### Site Plan Review

City of Rochester Hills  
Planning & Economic Development

Conditions and mark-ups noted throughout the plan set must be addressed prior to final approval.

**GATEWAY OF ROCHESTER HILLS**  
PART OF THE SOUTHEAST 1/4 OF SECTION 34, TOWN 3 NORTH, RANGE 11 EAST, CITY OF ROCHESTER HILLS, OAKLAND COUNTY, MICHIGAN

**UTILITY PLAN**

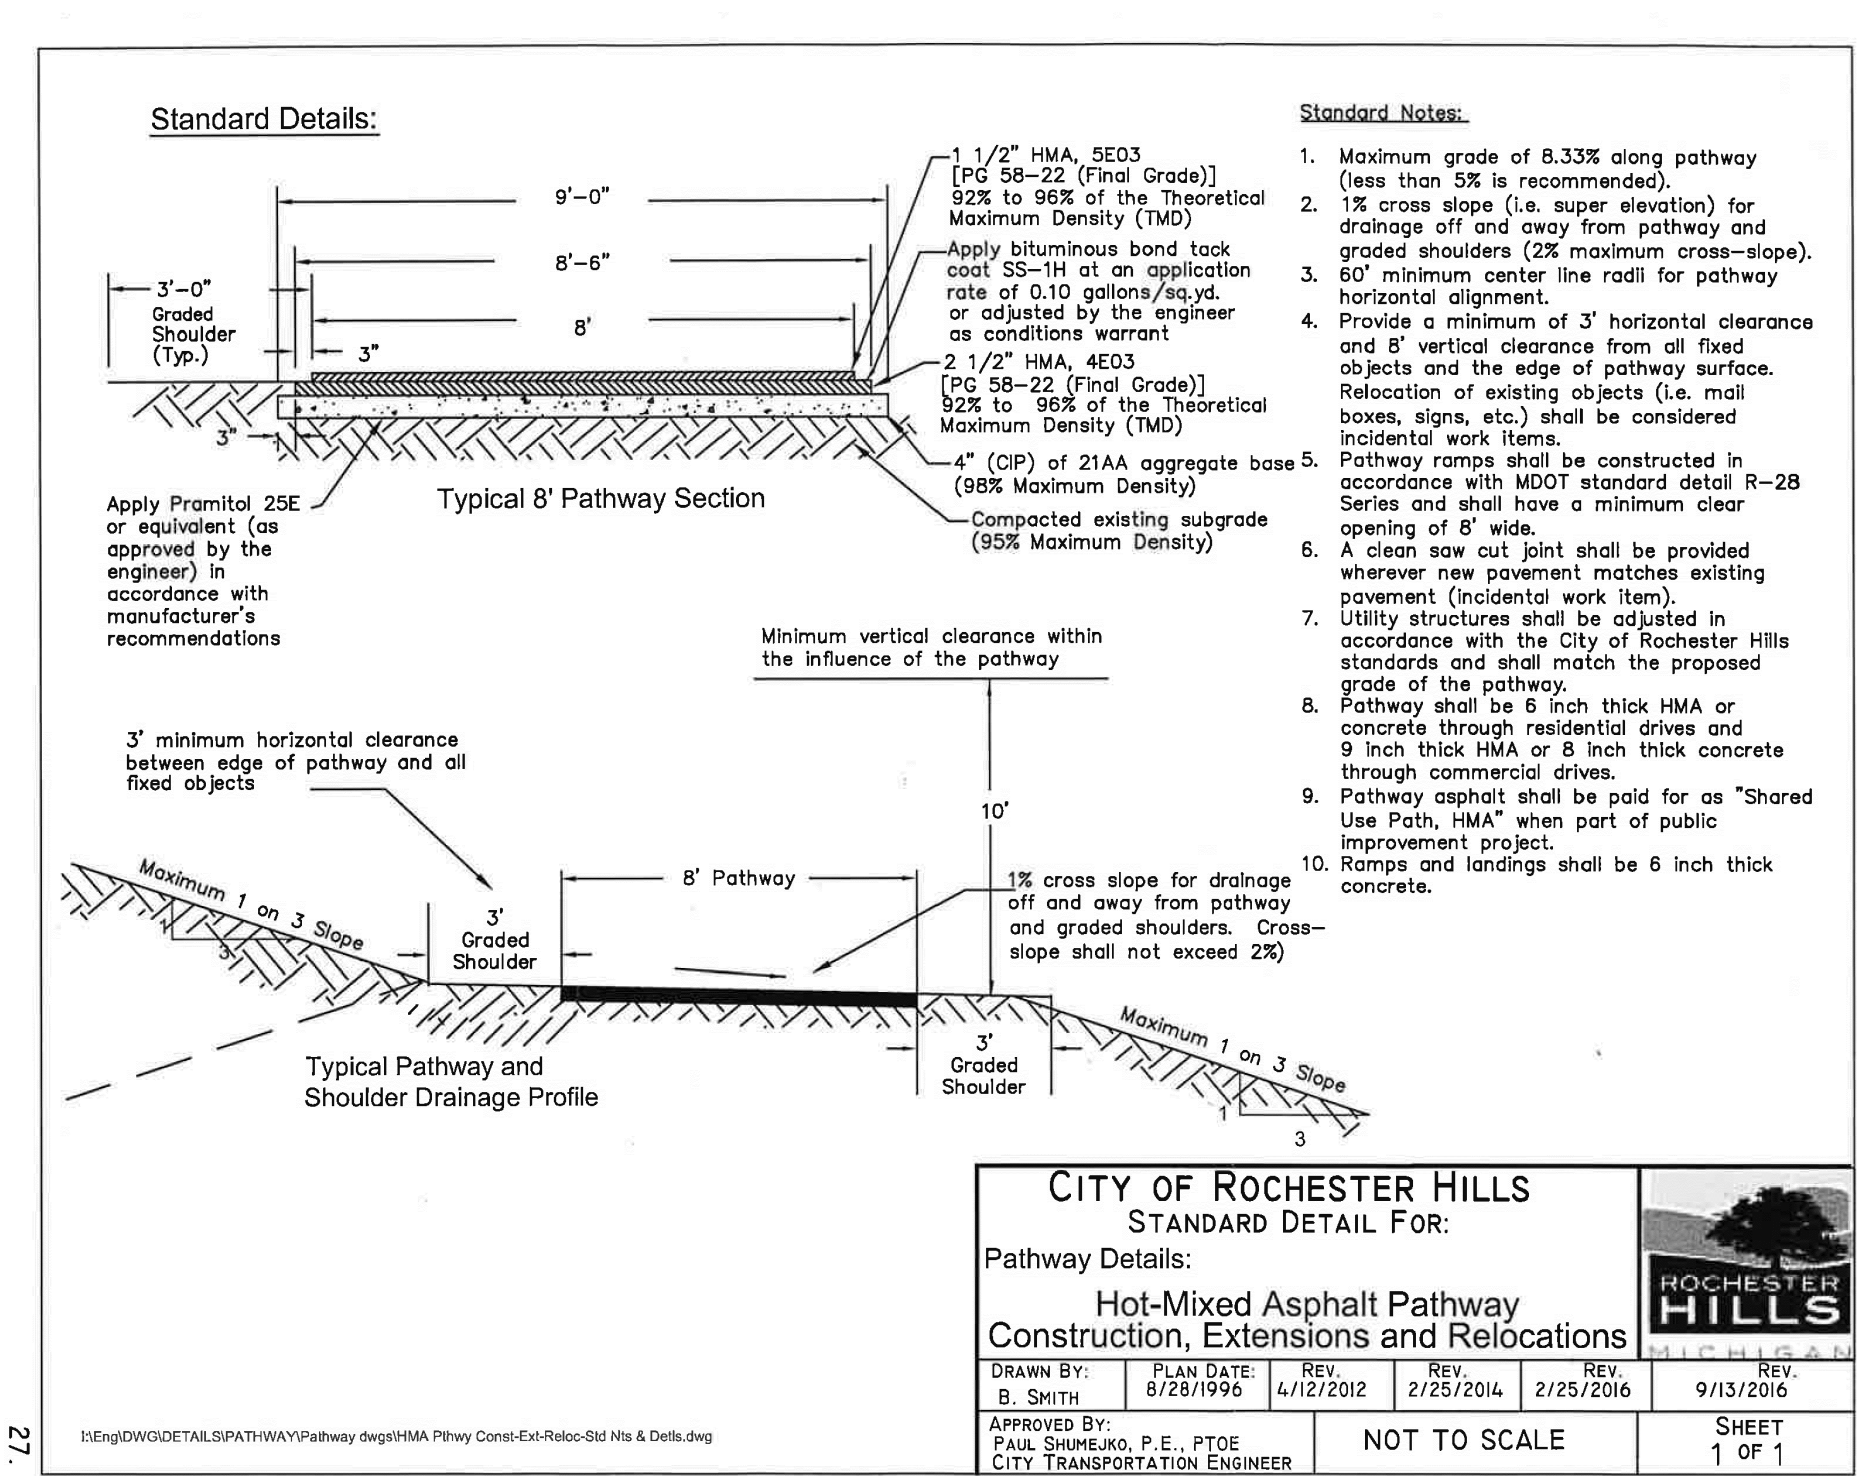
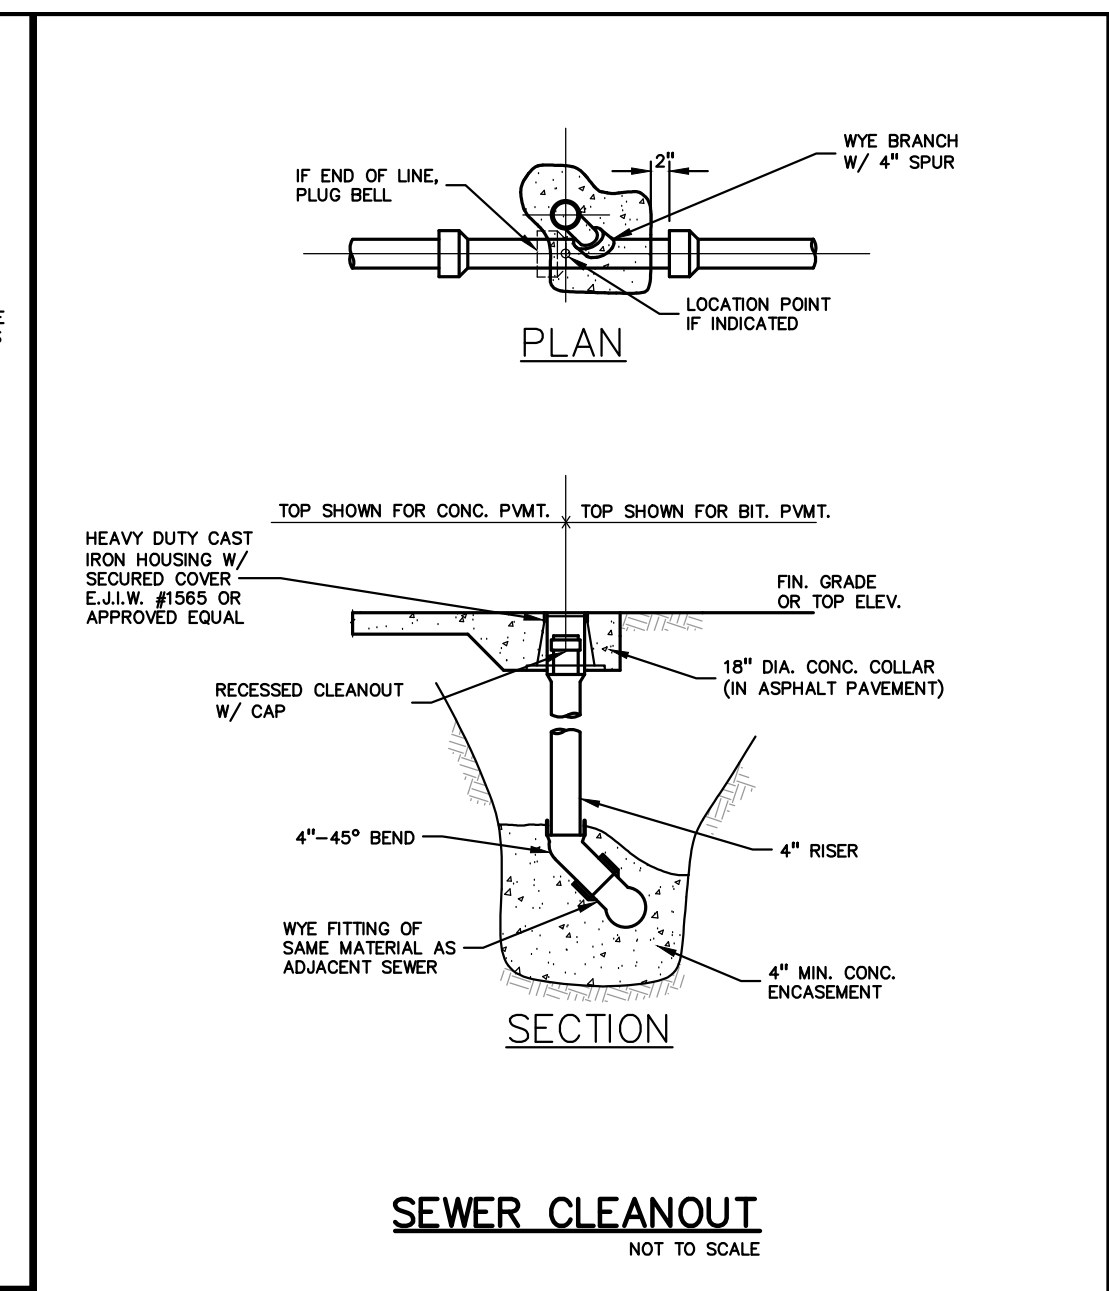
Revise to 95-044.3
